SERIAL NO.: 09/926,676

FOR: VACUUM PROCESSING APPARATUS

LETTER SUBMITTING DRAWING REPLACEMENT SHEET(S)

FIG. 1

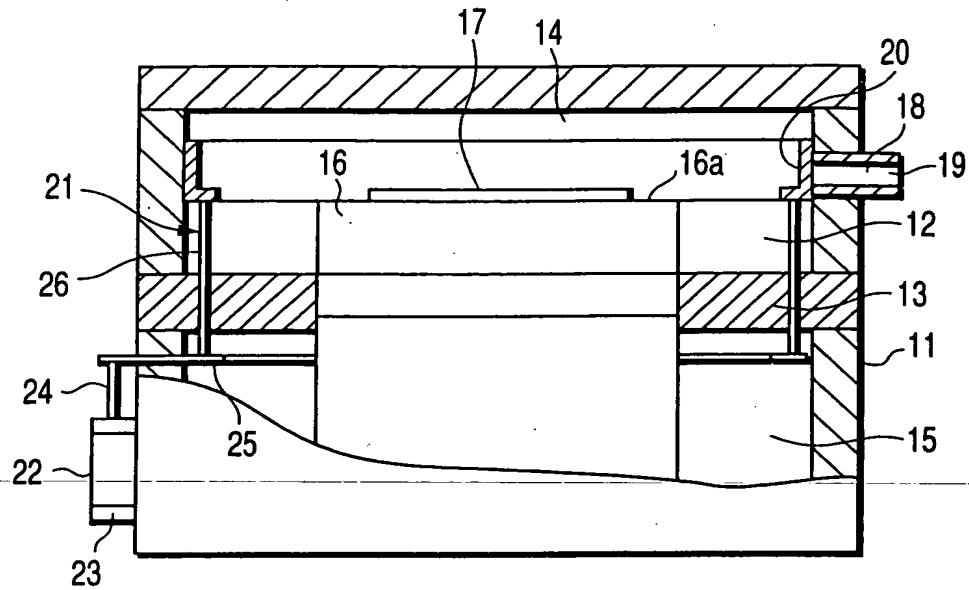
Applicants have submitted herewith replacement sheets for FIGS. 1, 10, and 7. FIG. 1 now contains an extended line from element 17 touching the substrate to be processed.

FIG. 7

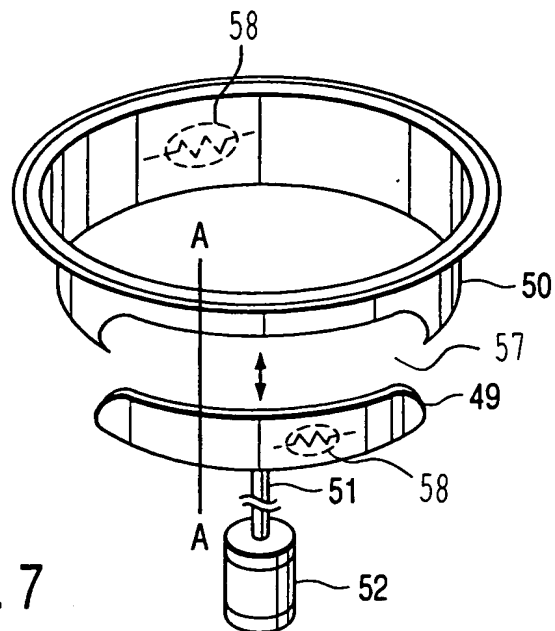
FIG. 7 now shows an electric heater 58 and a notch 57.

FIG. 10

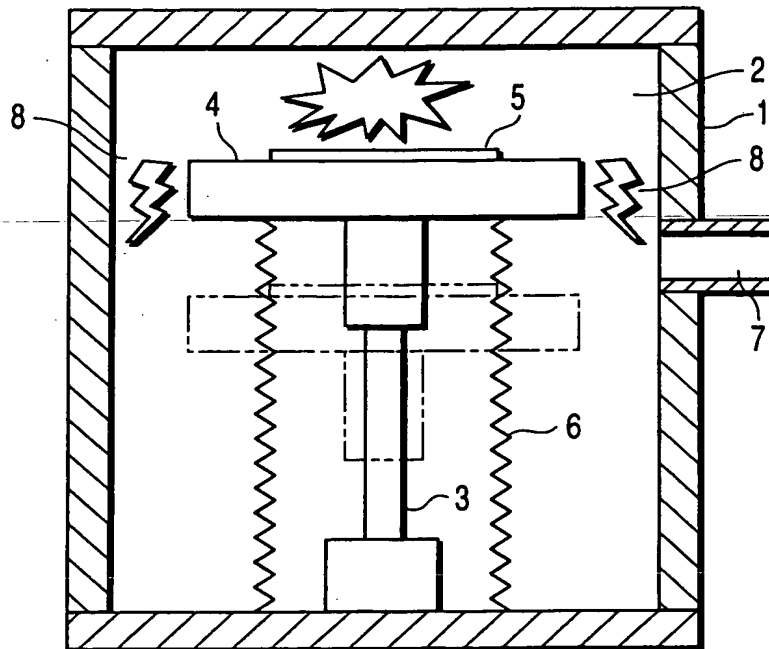
FIG. 10, now includes the label "prior art."
